Working Paper No. HDH-11-05e  
(11th HDH meeting, 10 to 12 October 2012)

# Results of Examination and Issues to Address Regarding WHDHC

JAPAN AUTOMOBILE STANDARDS INTERNATIONALIZATION CENTER

**WHDHC target power pattern during 660-720sec in total 1800sec\_96kW**

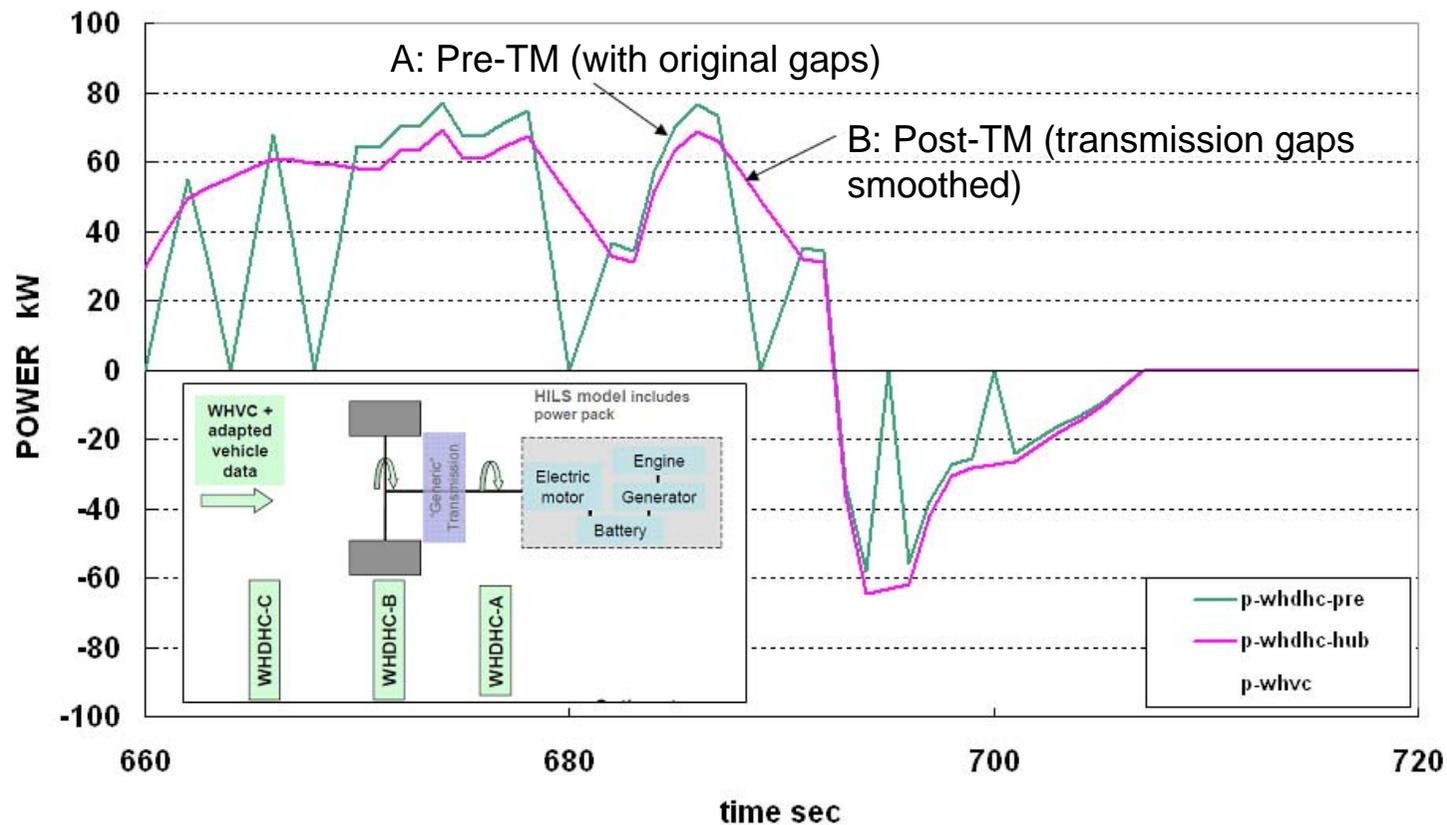
\* In WHDHC's power patterns, there are zero-gaps derived from transmission shift-changing events.

It is unnecessary to include these gaps for Post-TM, because the shift-changing timing should be determined by the real control; If they were included in the target patterns, the shift-changing timing would become out of reality and design by manufacture. On the other hand, for Pre-TM, basically there is no unreasonableness with gaps like in WHTC.

Proposed pattern is to smooth these gaps on original one. (Post-TM)

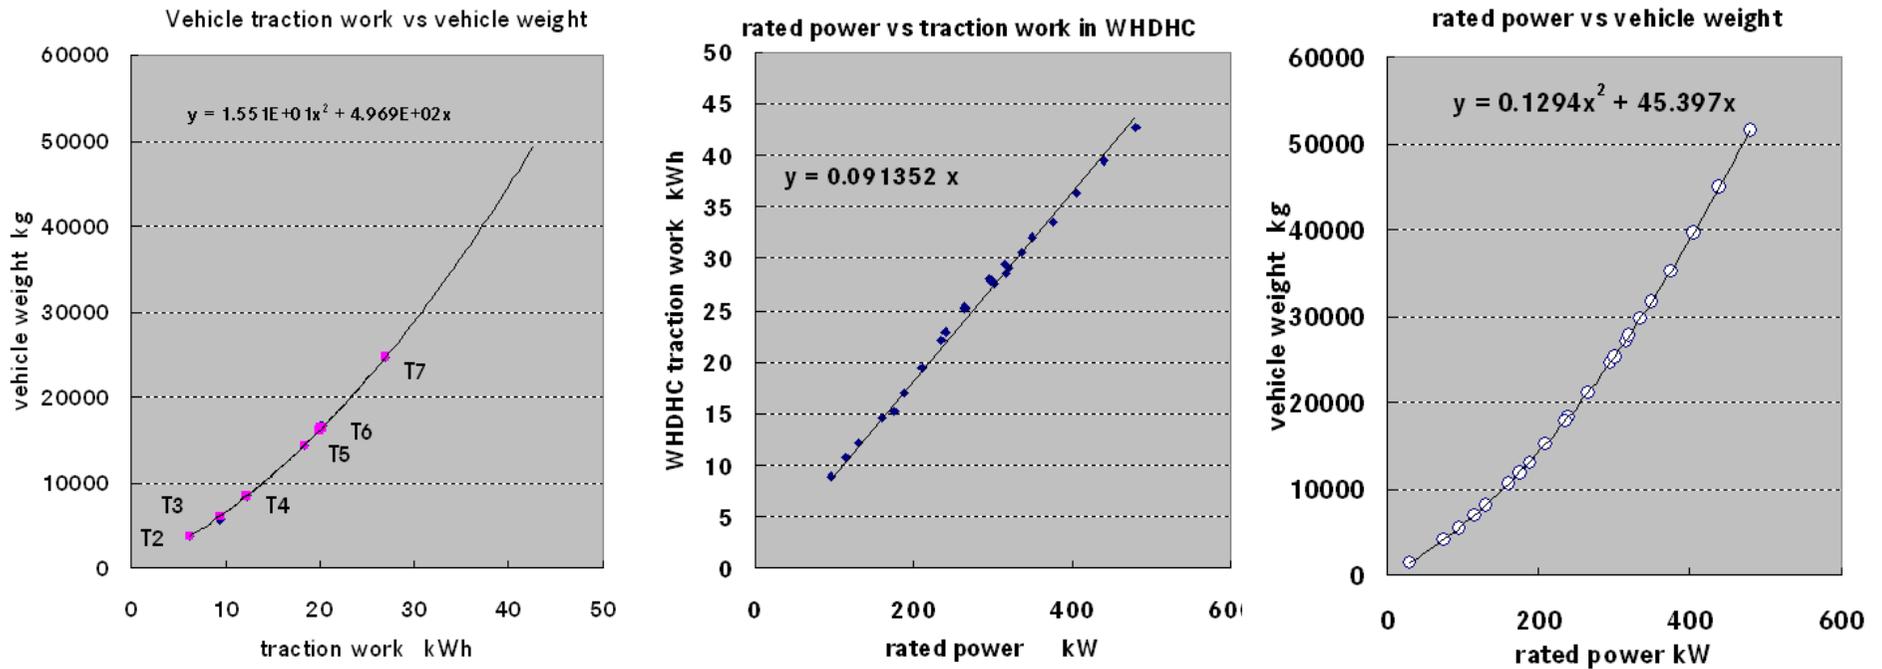
\* In vehicle-based simulation, for adjustment to WHDHC' s target power patterns, the weight based on the standard vehicle specifications, as specified in T1-T7, creates large divergences in some cases (see p. 7).

As a solution, it would be good to newly define the vehicle weight that is correlated with the rated power.

To do this, for the positive side and the negative side, respectively, we approximated the relations among rated power, cycle work and vehicle weight and obtained relational expressions between rated power and weight.

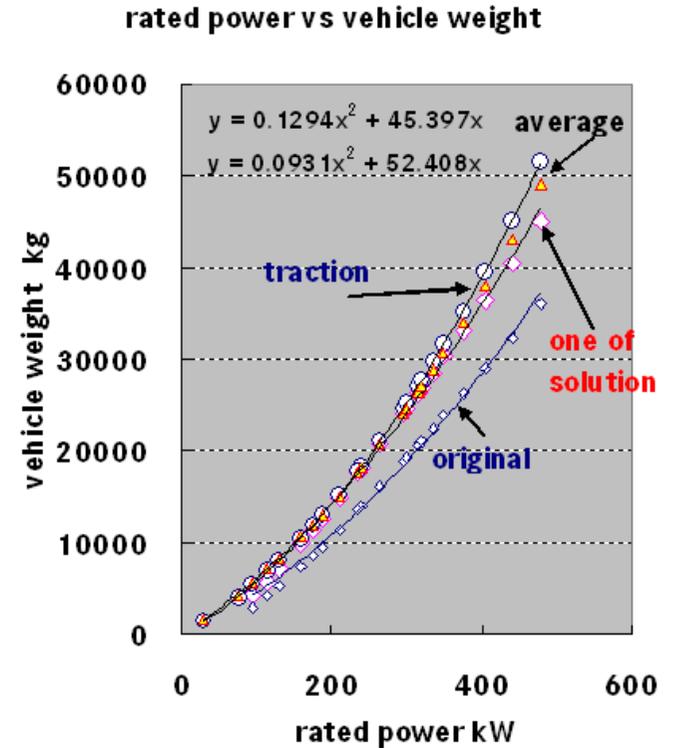
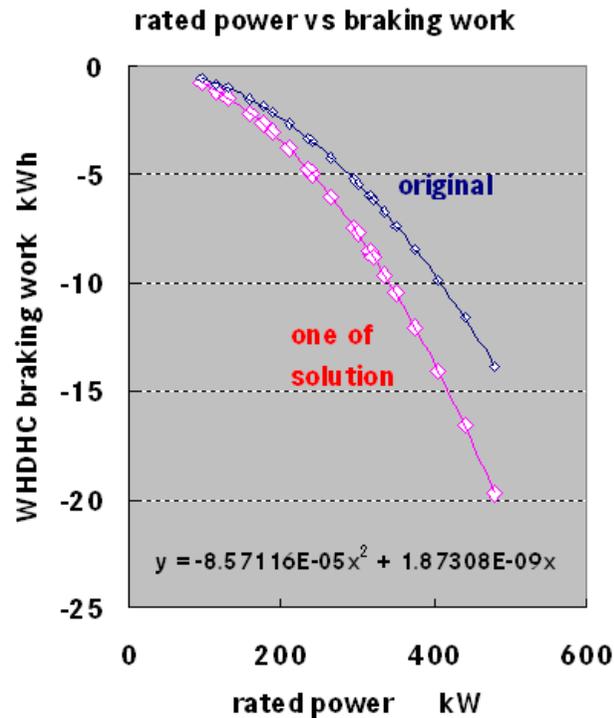
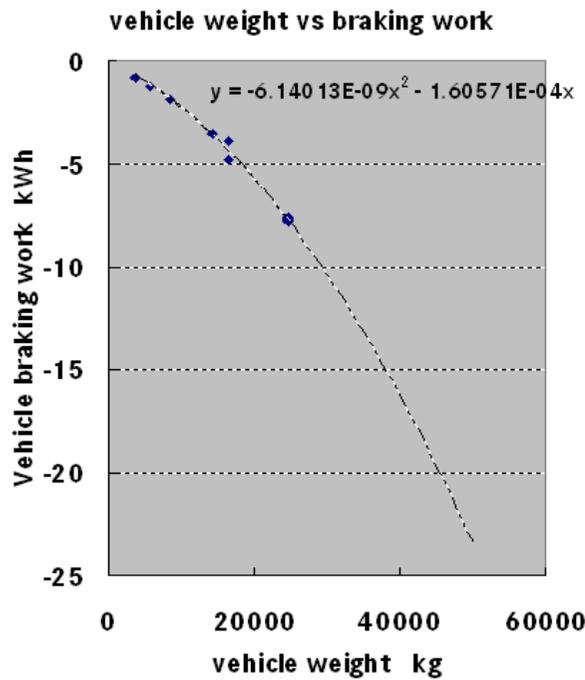
\* We averaged the relational expressions between rated power and weight obtained for the positive side and the negative side, respectively, and had the following expression:

Idea; Vehicle weight (kg) = 0.111265 x (rated power kW)<sup>2</sup> + 48.9025 x (rated power kW)

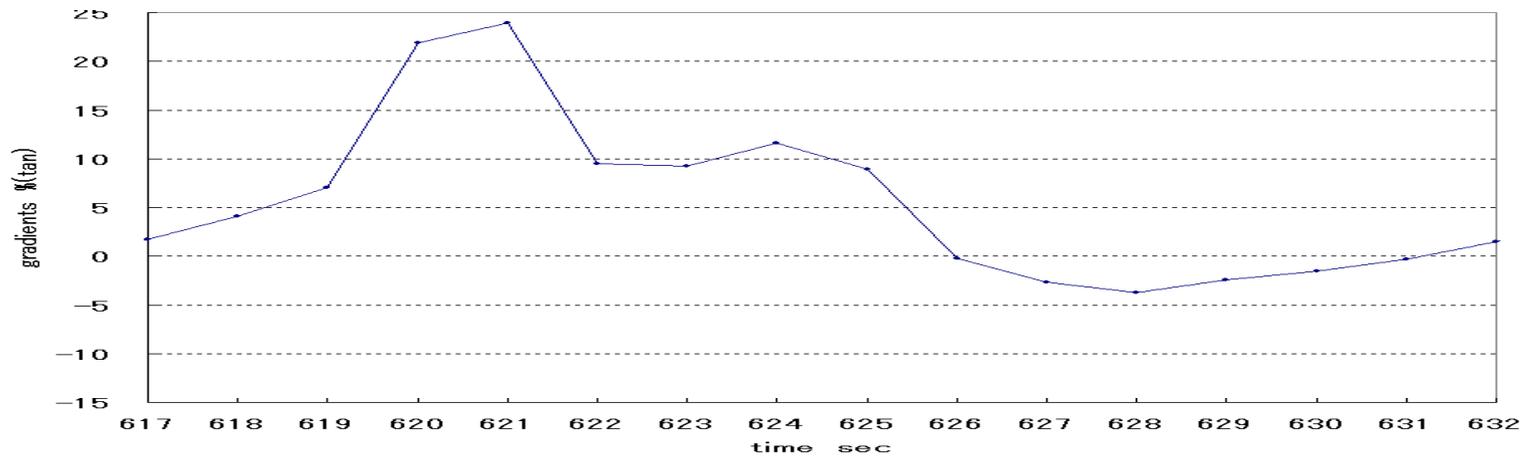
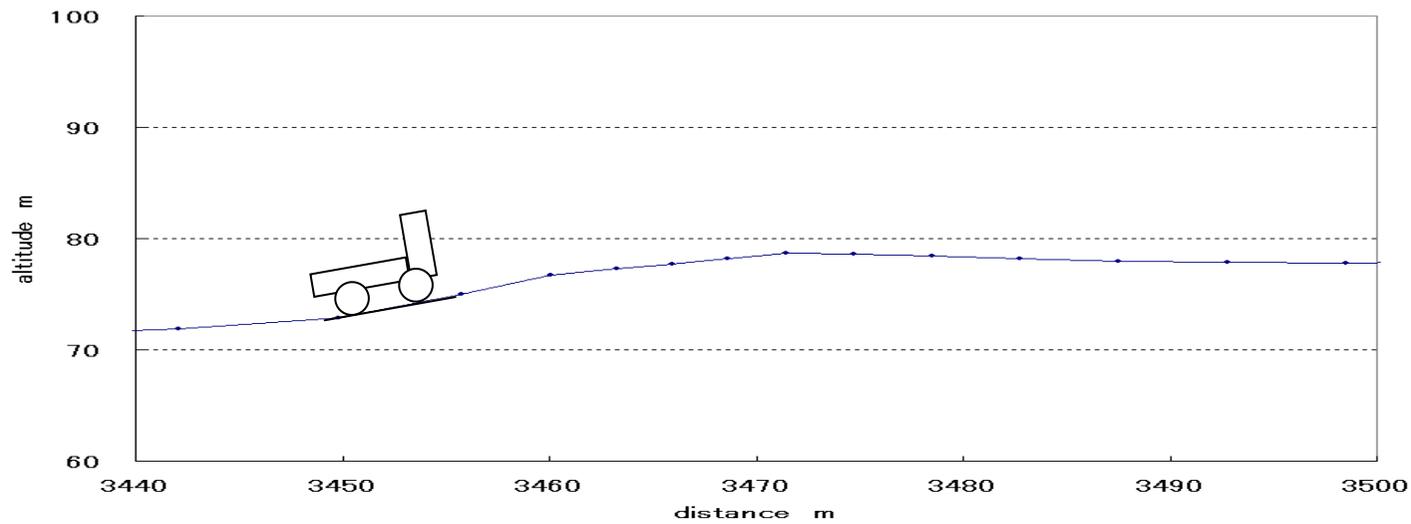
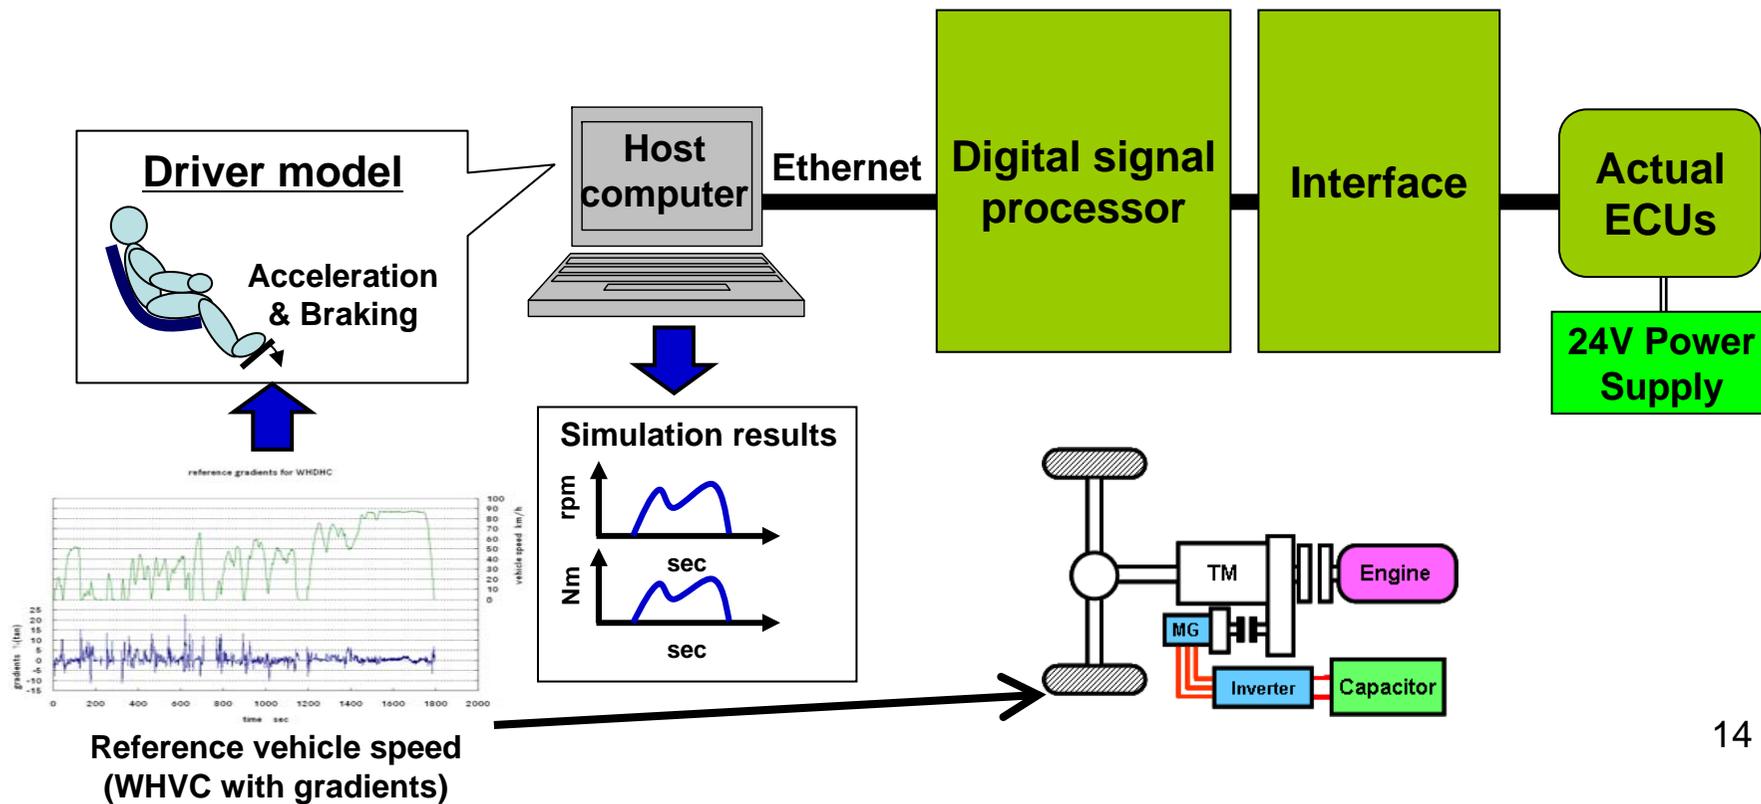
\* However, we determined that it was impossible to track WHVC with gradients on a chassis dynamometer. The graphs below show a part of the altitudes and gradients. You can see how difficult it would be to track the vehicle speed with gradients which change every second for 30 minutes.

\* In HILS, we consider such tracking possible if we have the refined driver model or accelerator or brake opening patterns tuned many times in advance.

Here, we can propose to perform the HILS accuracy verification on practical condition and the emissions simulation using gradients. If this works out, simulation that reproduces WHDHC Post-TM power patterns using an open-source model should be possible.

If tracking cannot be done even with this HILS simulation, then the “WHVC + WHTC’ s torque correction” method proposed by JASIC will be desirable.

Torques determined with WHDHC and convDHEV and gradients calculated from the torque differences

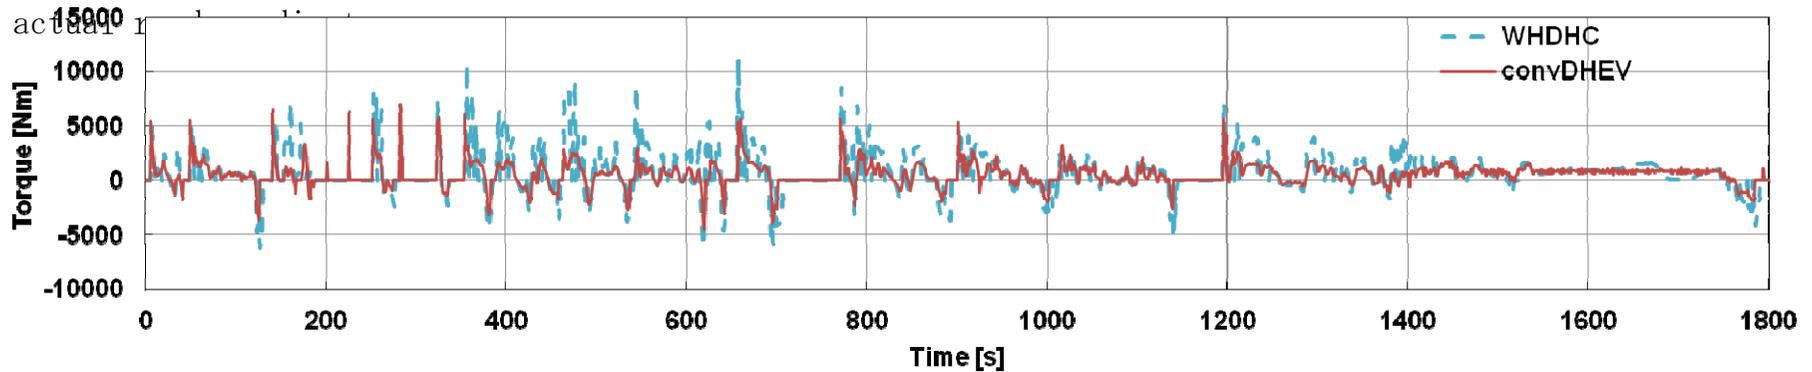
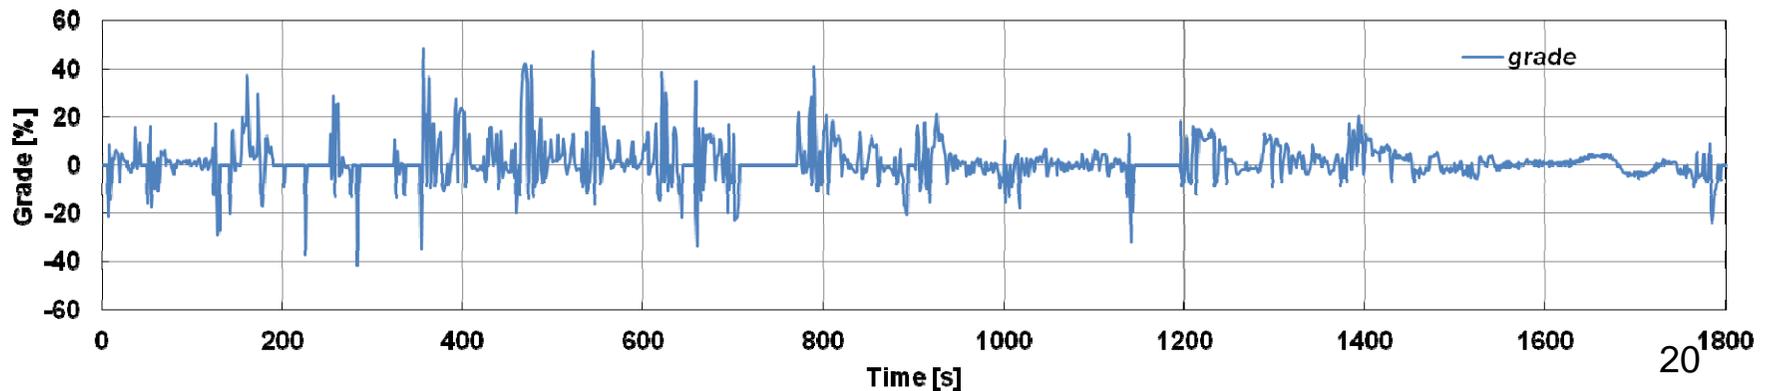
A large difference between torques calculated with WHDHC and those with convDHEV was observed in many parts. The maximum required gradient that was calculated was 49.9%, which deviates greatly from the

Results of Run on WHVC (with gradients) in HILS

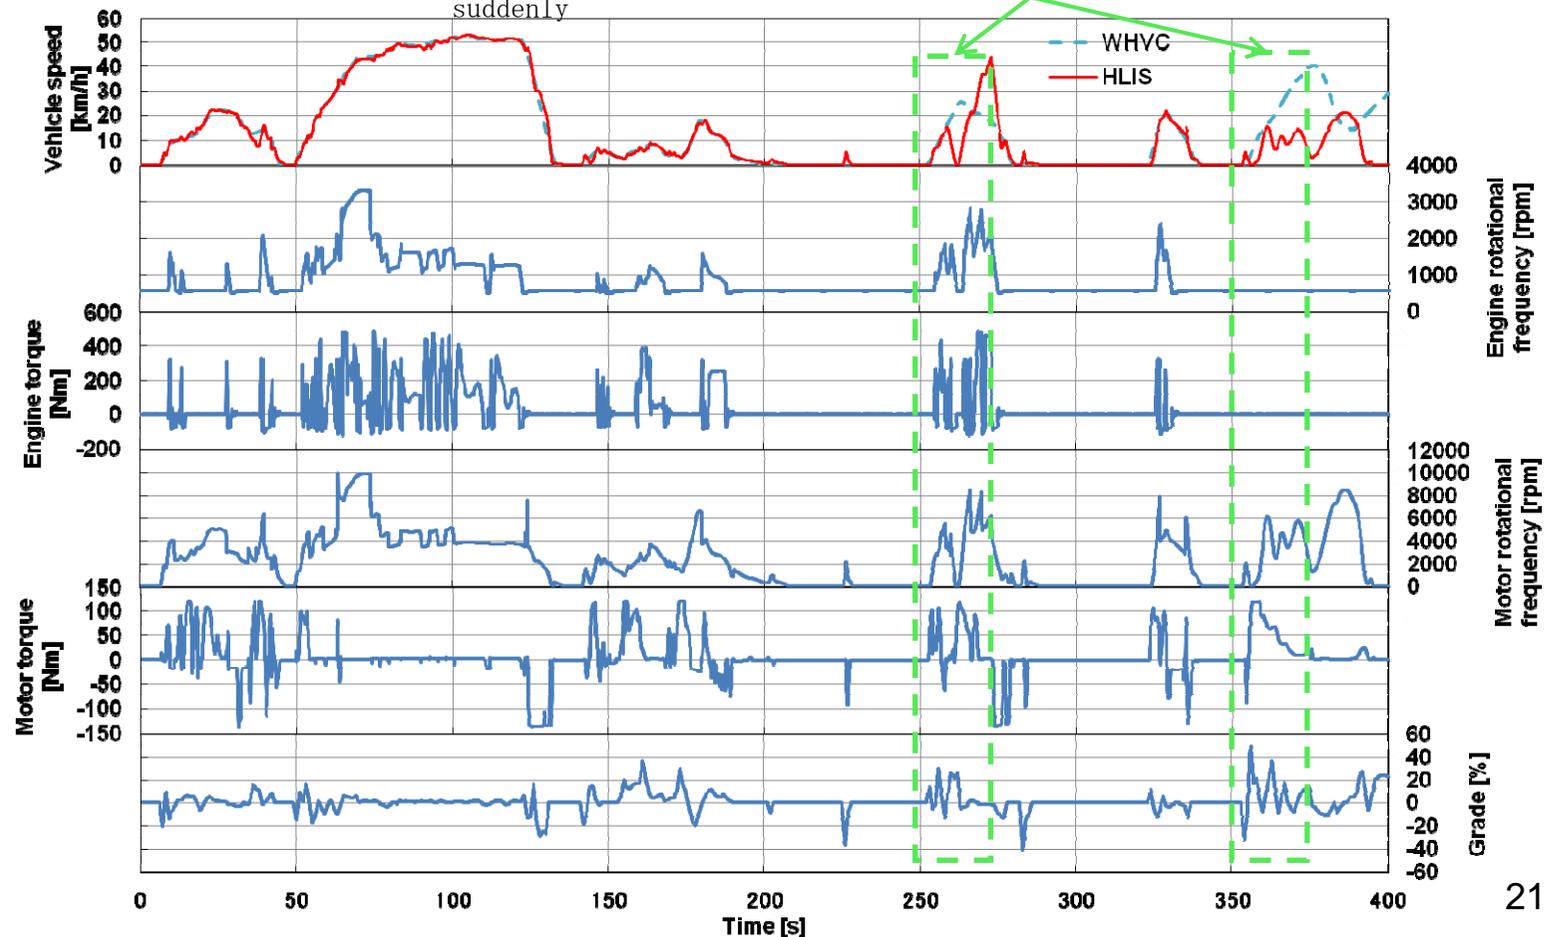
In the simulation, an HECU error (clutch-related) occurred at around 350 seconds, where a large ascending gradient entered, or stopped responding to the torque command at the same point, making it impossible to continue simulation.

The cause of the error is presumed Tracking of the target vehicle speed stops when a large gradient change occurs suddenly

Vehicle-less HILS that tracks the torque

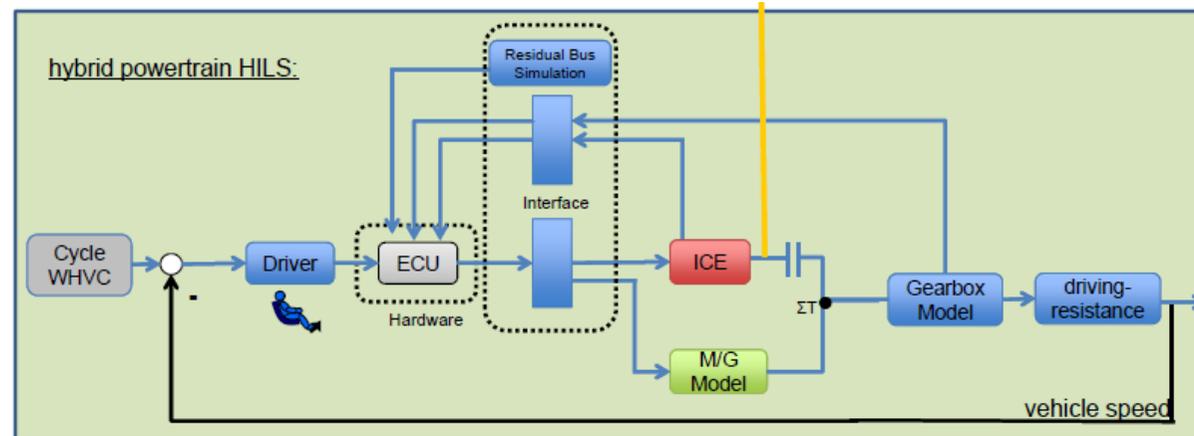
1. The HILS that tracks the torque without the vehicle, proposed by TU Wien, would be fundamentally different from the vehicle-based HILS, and therefore there are many problems including re-development of the model, renovation of the actual ECU, and difficulty of verification of HILS.
